**TSG-RAN Meeting #13
Beijing, China, 18 - 21 September 2001**

RP-010538

Title: Agreed CRs (Release '99 and Rel-4 category A) to TS 25.303

Source: TSG-RAN WG2

Figure 30: Radio Link Addition

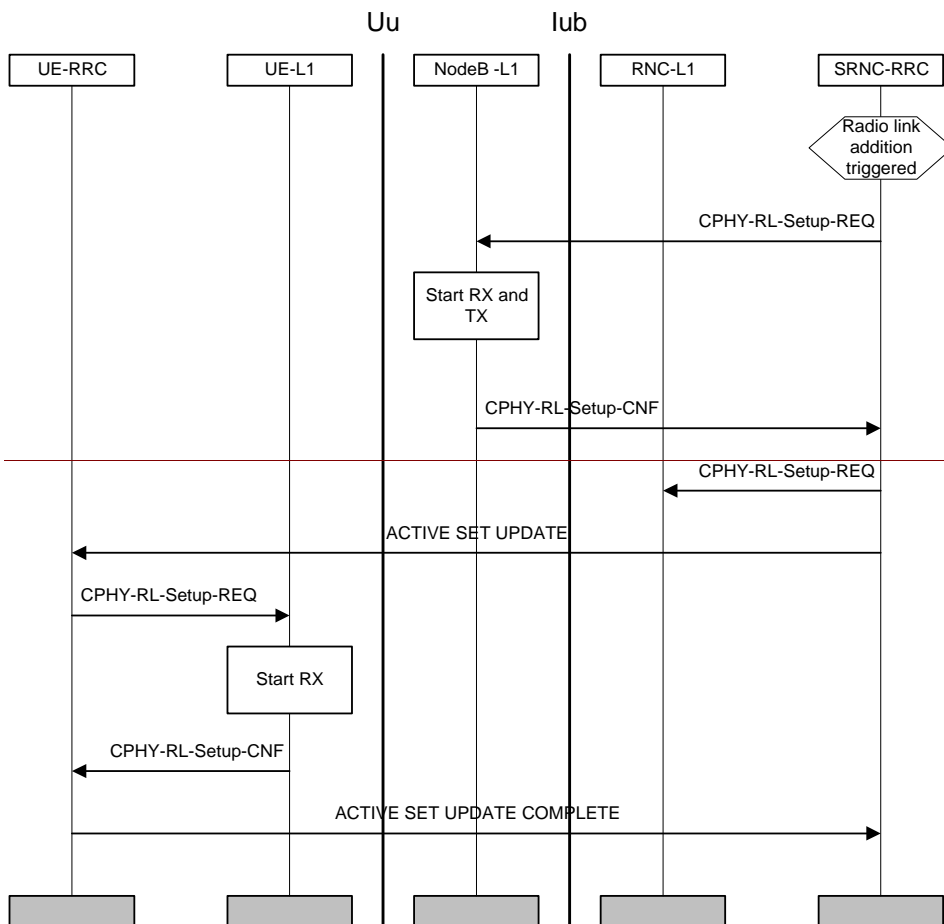
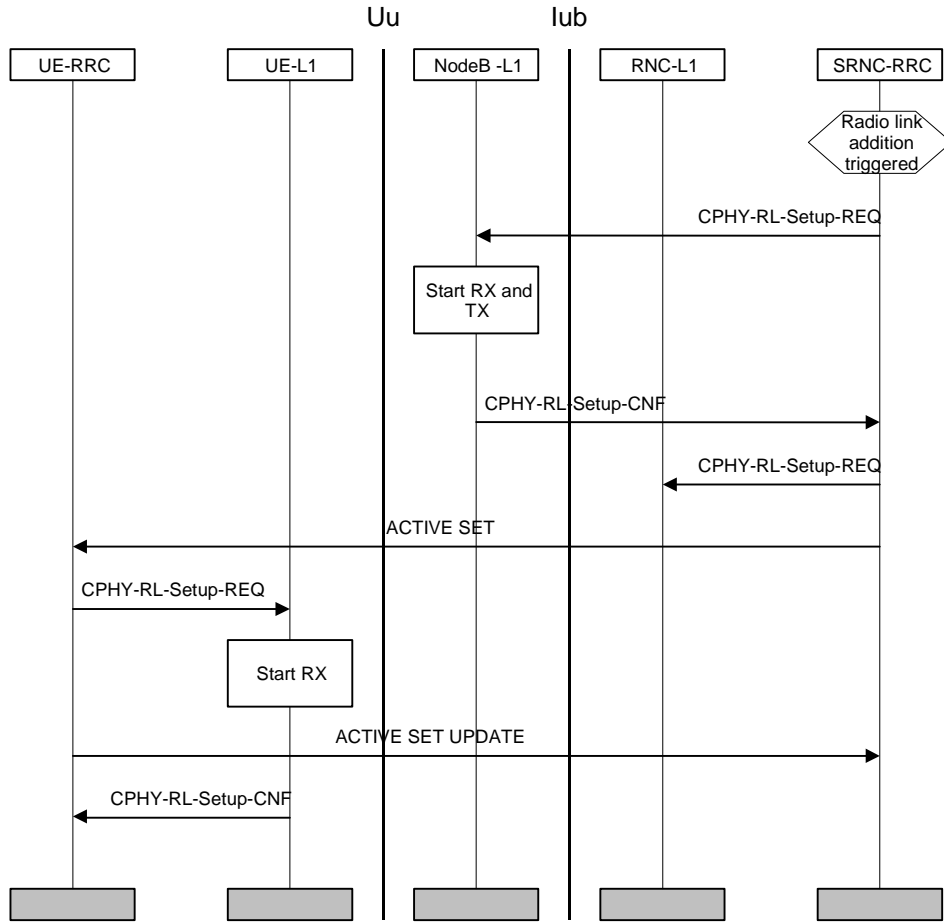
Reason for change:	⌘ It is stated in section 8.3.4.3 of 25.331 that after receiving an ACTIVE SET UPDATE message the UE shall - 'transmit an ACTIVE SET UPDATE COMPLETE message on the uplink DCCH using AM RLC without waiting for the Physical Layer synchronization;'
	However in section 6.4.4 of 25.303 it states the UE shall wait for indication from the physical layer before sending the ACTIVE SET UPDATE COMPLETE message. This is wrong and is corrected.
	Isolated impact analysis:
	This correction is to a function where the specification was not sufficiently explicit. This would not affect implementations behaving like indicated in the CR, but would affect implementations supporting the corrected functionality
Summary of change:	⌘ The UE does not need to await indication of layer 1 synchronisation before sending the ACTIVE SET UPDATE COMPLETE message to the UTRAN.
Consequences if not approved:	⌘ Increased delay in performing Active Set Update procedure

~~After confirmation from the physical layer in~~The UE shall send an ACTIVE SET UPDATE COMPLETE message is sent to the RNC-RRC without waiting for an indication of synchronisation from the UE physical layer.

Figure 35: Combined Hard Handover and SRNS relocation (lossless radio bearers)

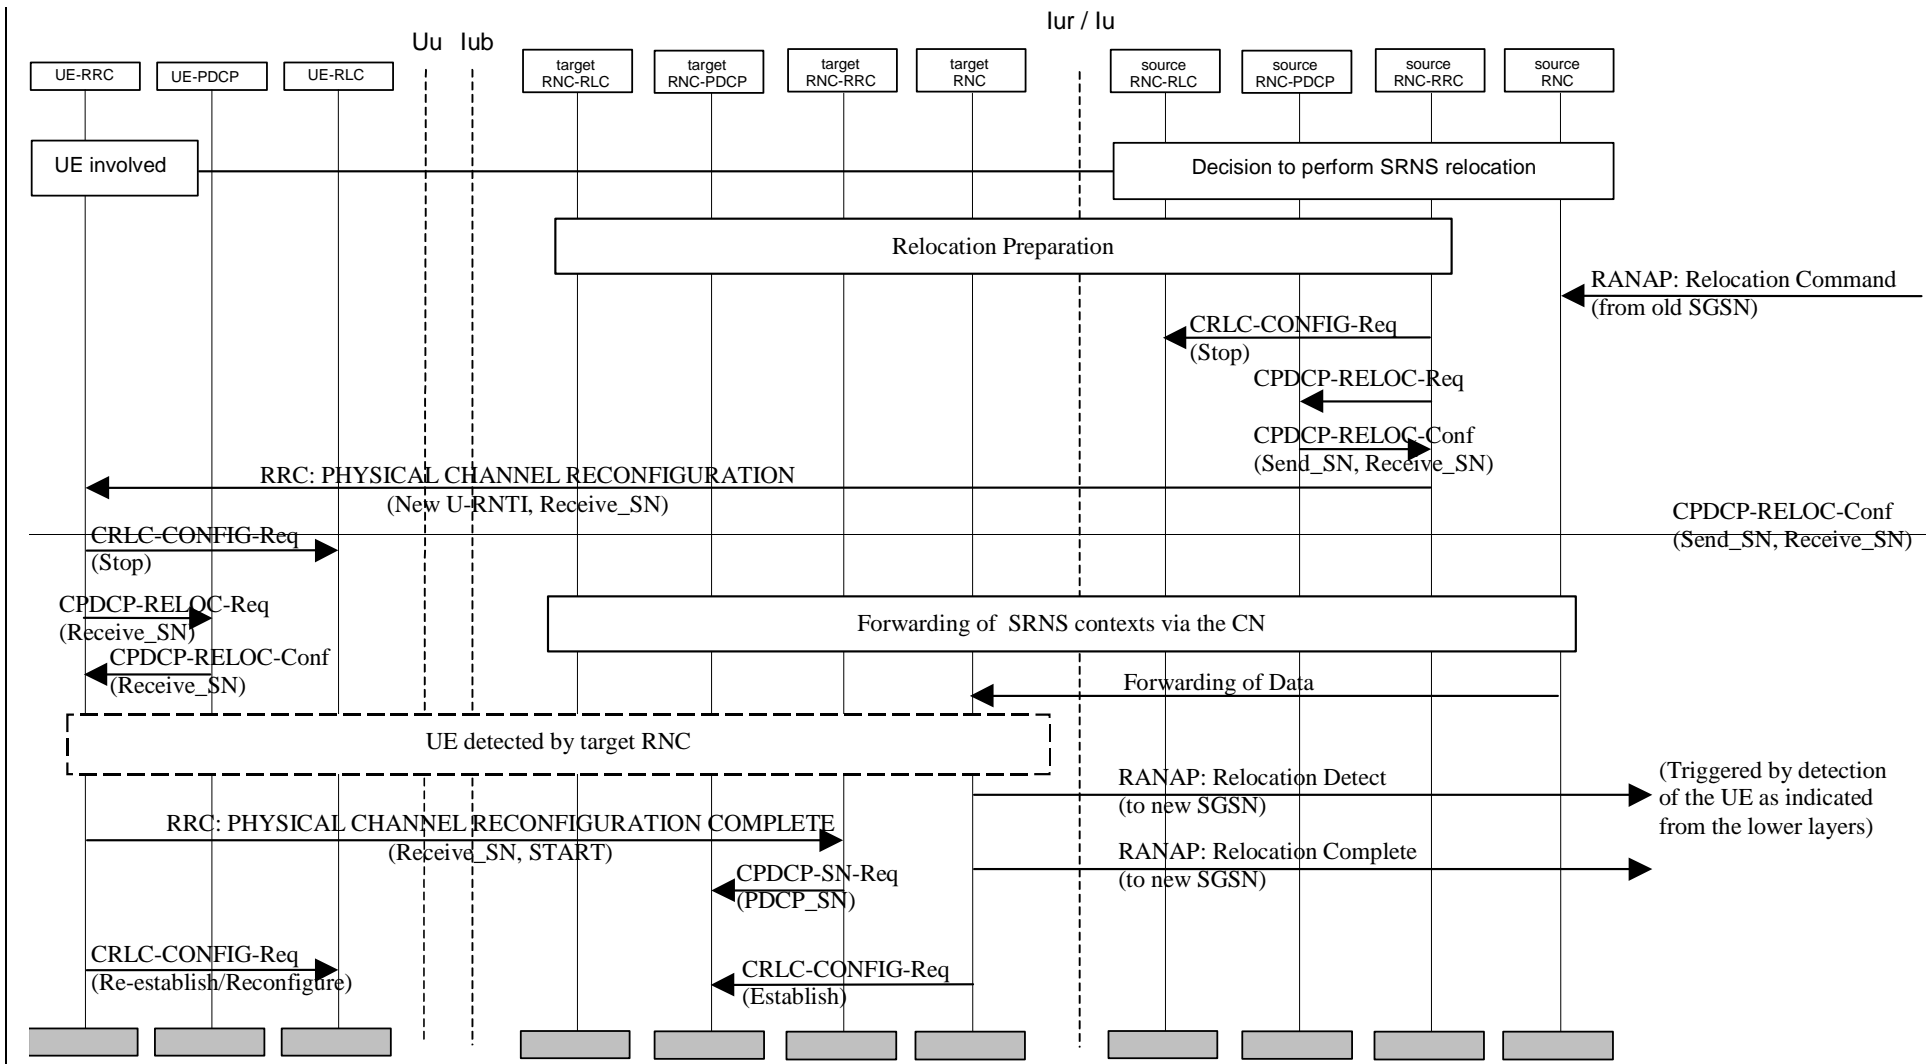
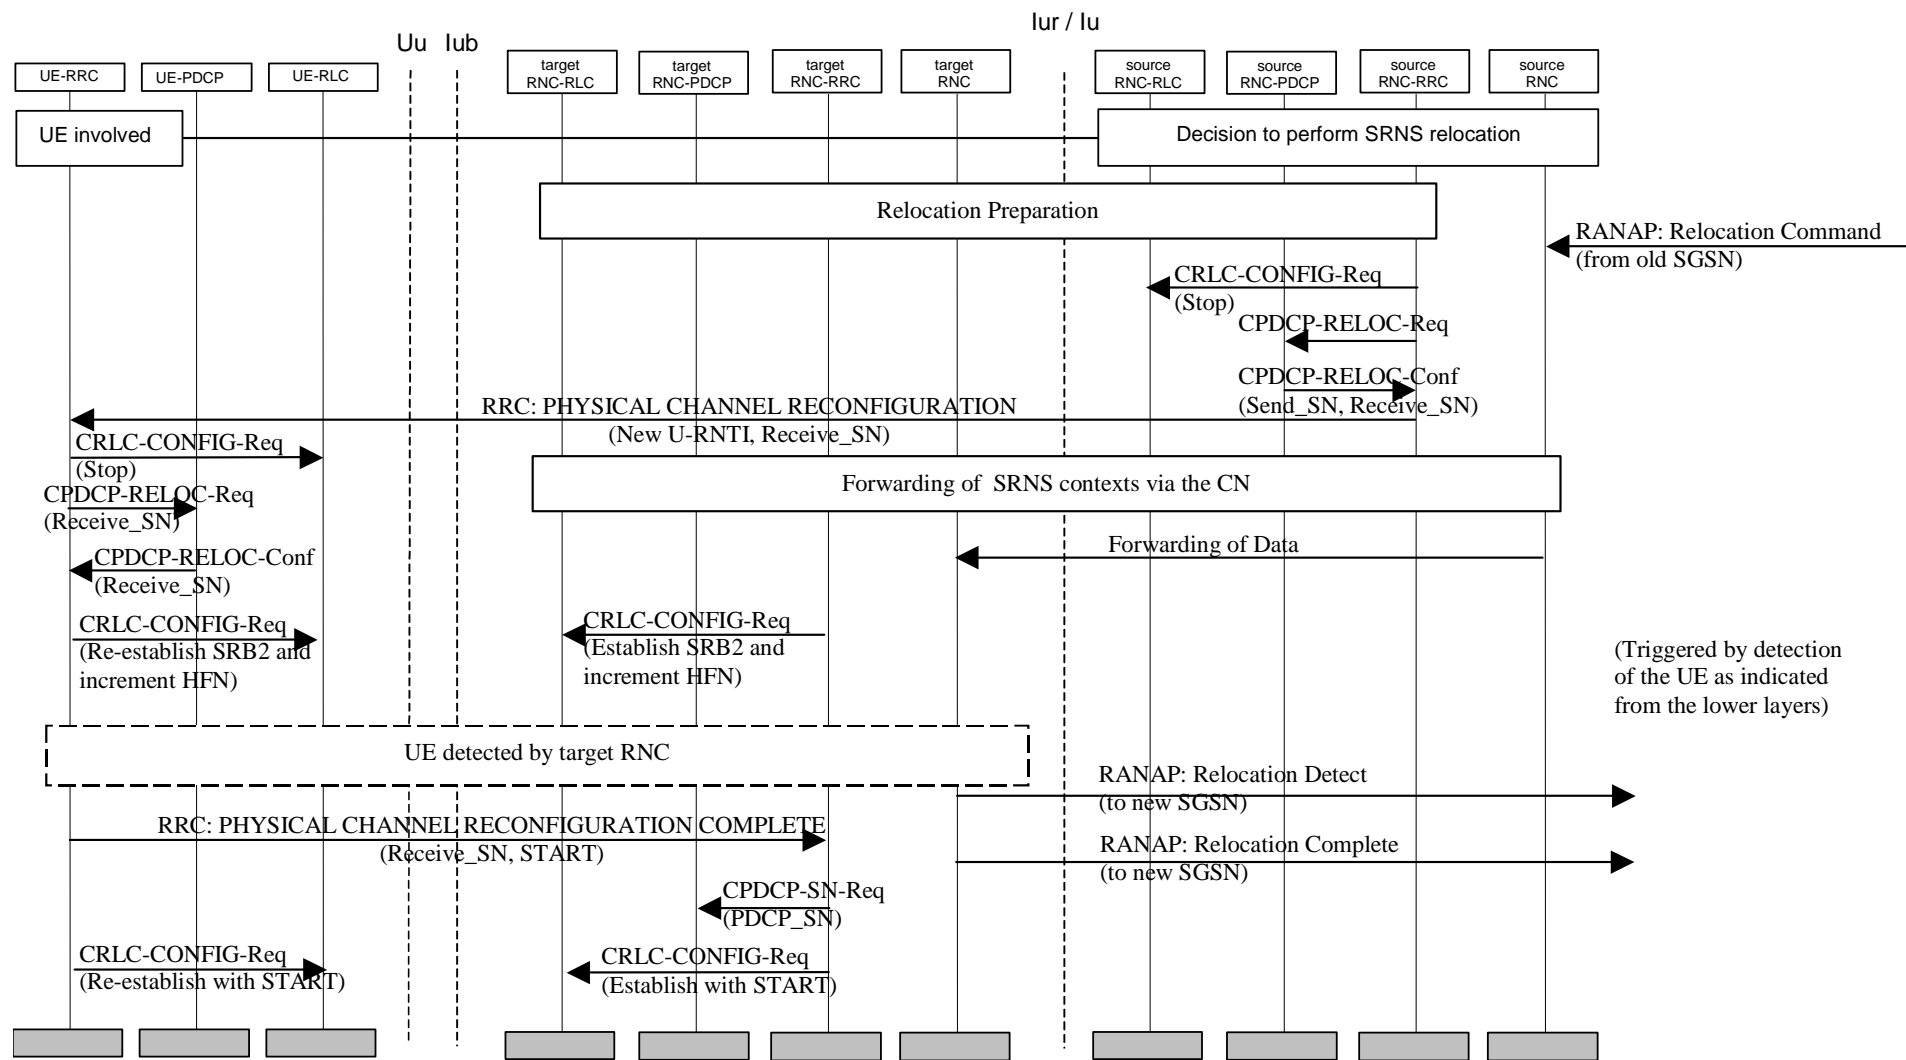
Reason for change:	⌘ In the way the current description is specified, it is not possible for the target RNC to receive the uplink response from the UE since the RLC state was lost during SRNS relocation. For this message to go through, at least the RB on which the message needs to be re-established using a START value that is known both at the UE and in UTRAN.
Summary of change:	⌘ It is suggested to perform RLC re-establishment of SRB2 before transmitting the response on the uplink. Then, after the response message is transmitted, to use the START value transmitted in this message to re-establish the rest of the RBs and SRBs.
	This change affects lossless and seamless SRNS relocation in CELL_DCH.
	The CR has isolated impact and should be seen as a correction.
Consequences if not approved:	⌘ SRNS relocation, lossless or seamless will not work in dedicated mode.

~~For the affected radio bearers, the RLC entity is stopped and the PDCP sequence numbers are retrieved by RRC. The PDCP send and receive sequence numbers and the last START current downlink and uplink HFN values received from the mobile are then transferred via the CN during the forwarding of SRNS contexts, via the CN phase from source to target RNC for RABs that support lossless SRNS relocation. The target RNC becomes the serving RNC when the RANAP Relocation Detect message is sent.~~

Upon reception of the RANAP Relocation Command, the RRC entity in the source RNC stops the RLC entities for the affected radio bearers and retrieves the PDCP sequence numbers. It then triggers the execution of the relocation of SRNS by sending the RRC message to the UE using the acknowledged mode dedicated signalling radio bearer (SRB #2). This message includes the new U-RNTI (from the target RNC) and the uplink receive PDCP sequence number for each radio bearer configured to support lossless SRNS relocation (from the source RNC). The UE compares the uplink receive PDCP sequence number with the uplink send PDCP sequence number. If this confirms PDCP SDUs successfully transferred before the start of relocation i.e. already received by the source RNC then these are discarded by the UE.

Upon reception and acknowledgment by the UE of the message, the RLC entities for the acknowledged mode dedicated signalling radio bearer (SRB #2) is re-established, both on the UTRAN and UE sides, are re-established and their HFN values are set to the current downlink and uplink HFN known START values incremented by one. Care should be taken by UTRAN in timing the SRNS relocation so that there is no risk of a SN rollover on SRB #2 during this procedure.

If the UE has successfully configured itself, it ~~shall~~ sends a response message, in this case a PHYSICAL CHANNEL RECONFIGURATION COMPLETE message to the target RNC using the acknowledged mode dedicated signalling radio bearer (SRB #2). This message contains the START values and the downlink receive PDCP sequence number for each radio bearer configured to support lossless SRNS relocation.

Upon acknowledgement of the message, the RLC entities for affected radio bearers are re-established both on the UTRAN and UE side. The HFN values for each RB are set to the START value in the message for the corresponding CN domain.
